### **General Compliance Request**

DP 05-292001

Application by Adera Equities Inc. for a General Compliance at

6033 Katsura Street (formerly 9180, 9186, 9200 and

### APPROVED SECTIONS

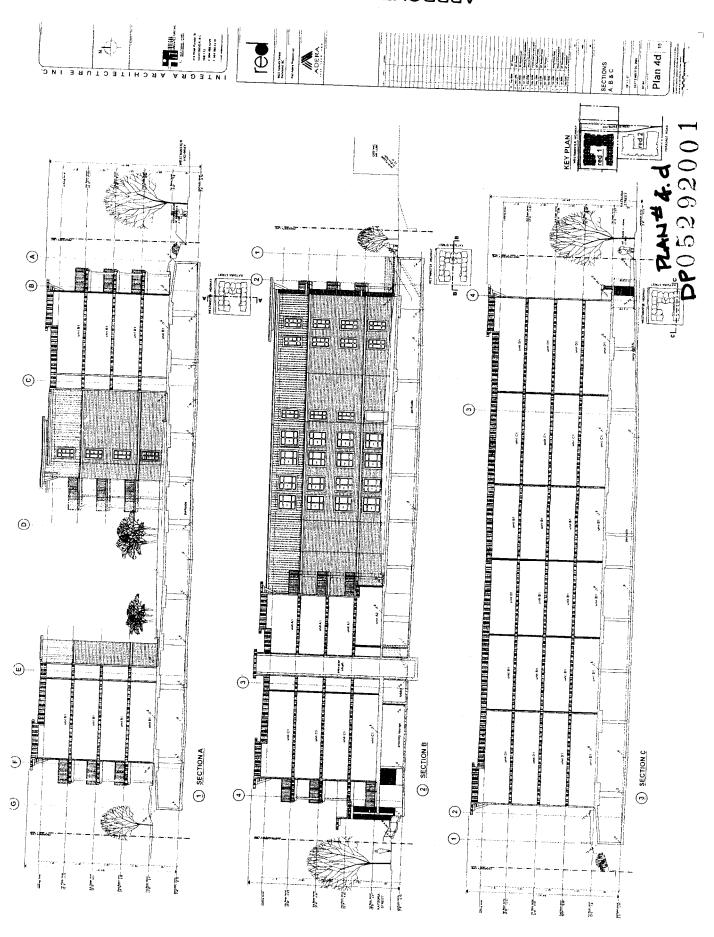
b) Deletion of the retaining wall and the landscape fill at the southwest corner of the site between the parkade and the property lines; and

The middle retaining wall between the parkade and the property line is no long required as the landscaping is now sloping down towards an opening in the parkade instead of sloping upward to the terrace (Attachment 14 & 15).

## APPROVED SOUTH ELEVATION

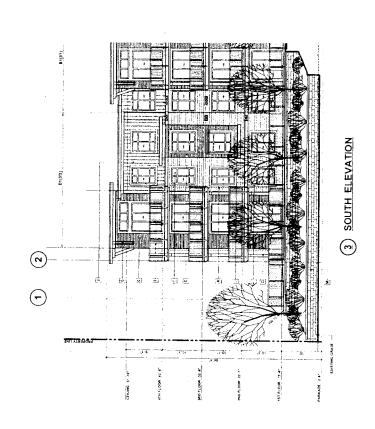
a) Addition of openings in the exterior parkade wall at the southwest corner of the parkade;

Openings are to be provided in the parkade wall to reduce the weight of the structure and to allow for structural steel levelling plates to be inserted between the top of the columns and the suspended slab (Attachment 10 -13). The openings in the parkade wall will be infilled with expanded metal mesh at the parkade area for security purposes. The openings in the parkade wall at the storage room will be infilled with a metal-framed wall and clad with sliding to match the building.

REVISED LANDSCAPE PLAN - SOUTHWEST CORNER

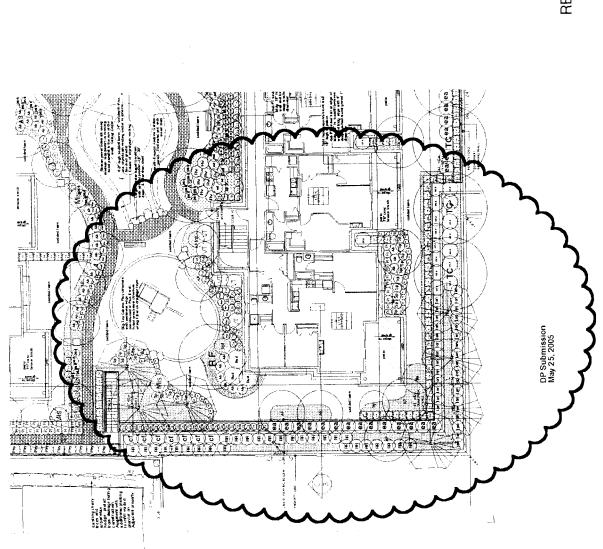
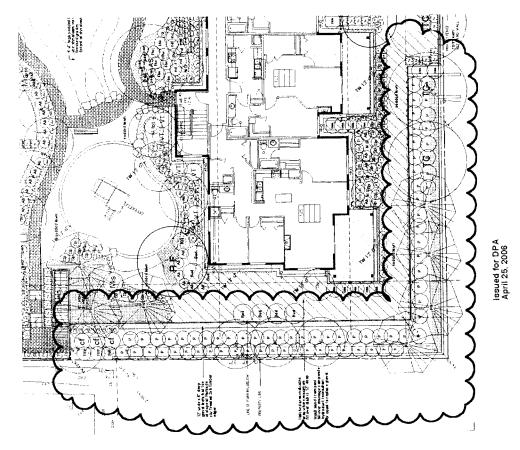
c) Adjustment to the landscaping at the southwest corner of the project.

Soil in the landscaping area has been reduced to 12 in. deep and drainage mats have been added in lieu of drain rock. Plants have been adjusted to be more drought tolerant / shallow soil tolerant at the top of the slab. Changes at the perimeter of the site have also been made as fill against the parkade has been reduced. Tree locations have been adjusted on the perimeter to better suit the aspect of the slope. Species of plants were changed to provide a broadleaf Evergreen hedge against the now exposed parkade wall (Attachment 16 & 17). The landscaping between the property line and the parkade wall will mature into a substantial visual screen that will effectively block the view of the parkade wall.
